Comments on Planning Submission 2016/6369/P

Figure 3. West East section through Grove End House and the gardens of Chetwynd Villas showing the impact of the proposed changes.

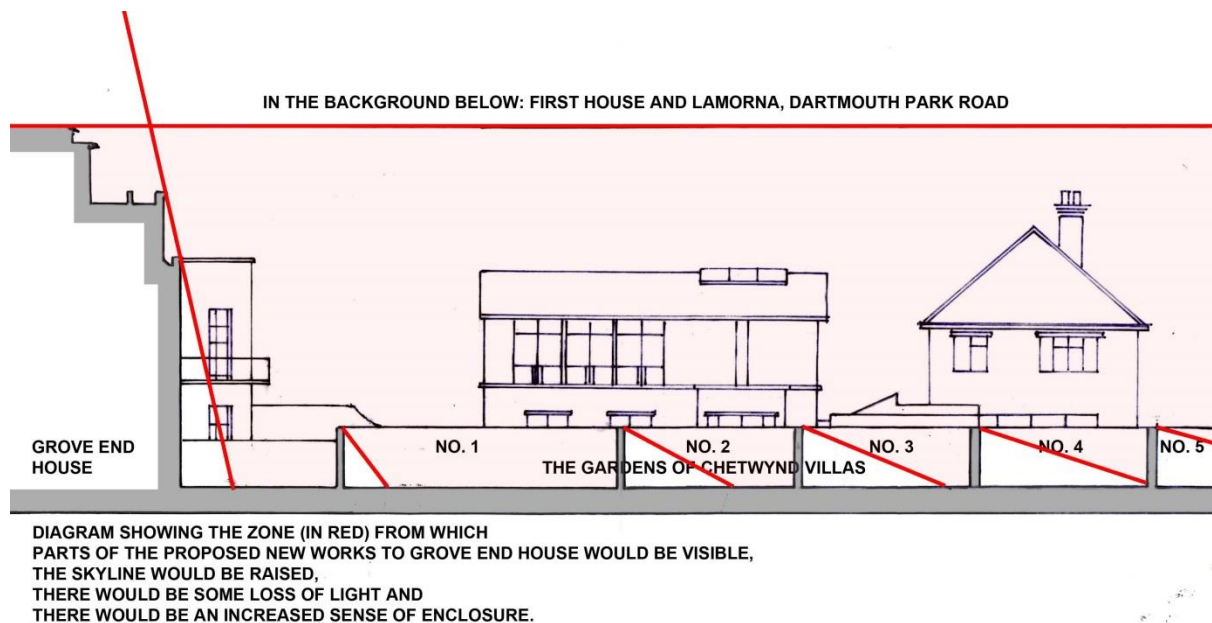
Any increase in the scale of Grove End House would have a further detrimental effect on the neighbouring properties. The section through Grove End House and the gardens of Chetwynd Villas below shows an area, in red, from any part of which the proposed new additions would be visible, the skyline would be raised and there would therefore be some loss of light and an increased sense on enclosure. It would be mainly the view from the gardens of 1 to 5 Chetwynd Villas that would be affected, but as can be seen from the CGI showing the view from the terrace of First House, Dartmouth Park Road, the view south from First House and its garden and from Lamorna would also be seriously affected.
